## G.O. No. 198 I., 3rd April 1913.

**Byewash in the left flood bank of the Cheyyar anicut.**

Sanctioning, with remarks, an estimate amounting to Rs. 10,086 inclusive of establishment charges for constructing a — North Arcot District.

E 177.

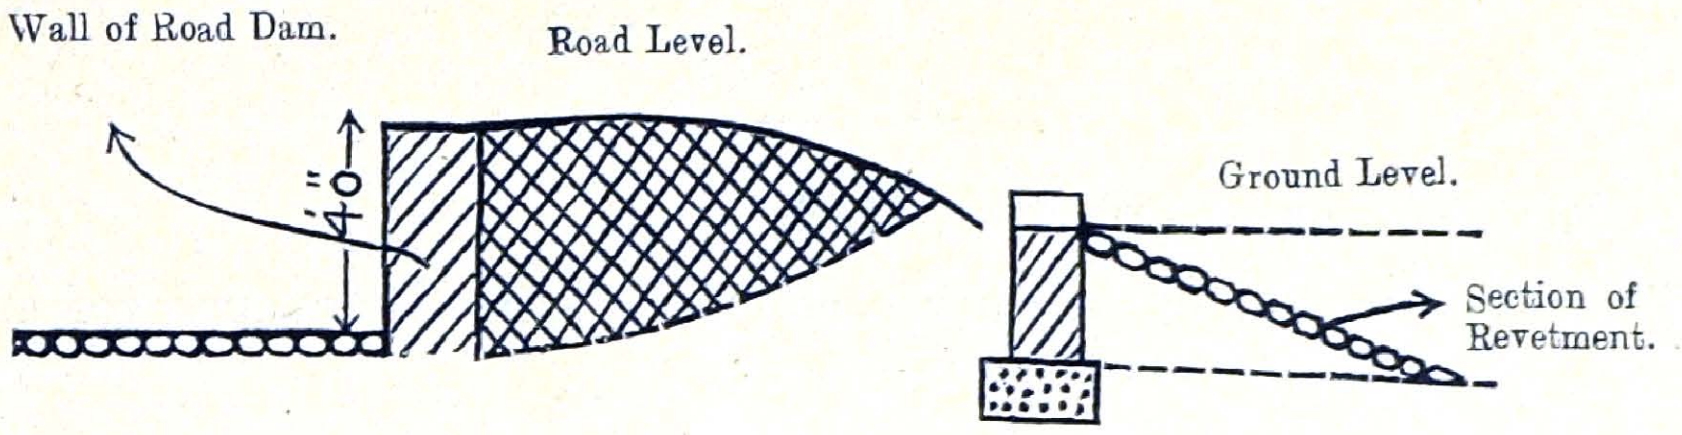
With reference to your No. 9-N.A., dated 6th January 1913, I have the honour to report that nothing occurred during the flood of 1912 to suggest the necessity of modifying the proposals for constructing a byewash in the left flood bank above Cheyar anicut except perhaps that from the way the road way was scoured out at the Road dam, it would appear advisable to strengthen this by constructing a wall on the upper side of the road as shown in red in sketch.

The wall of the road dam was not overturned but the earth above was scoured out down to apron level as shown in the portion cross hatched in sketch, and if the wall has overturned, the earth above which is chiefly sand would have cut back for some considerable distance. About $1\frac{1}{2}$ feet of water was flowing over the road dam for two days.

4. The question of strengthening the road dam referred to in letter No. 76 S.E., dated 26th January 1913, from the Executive Engineer, North Arcot Division, has been taken up separately.
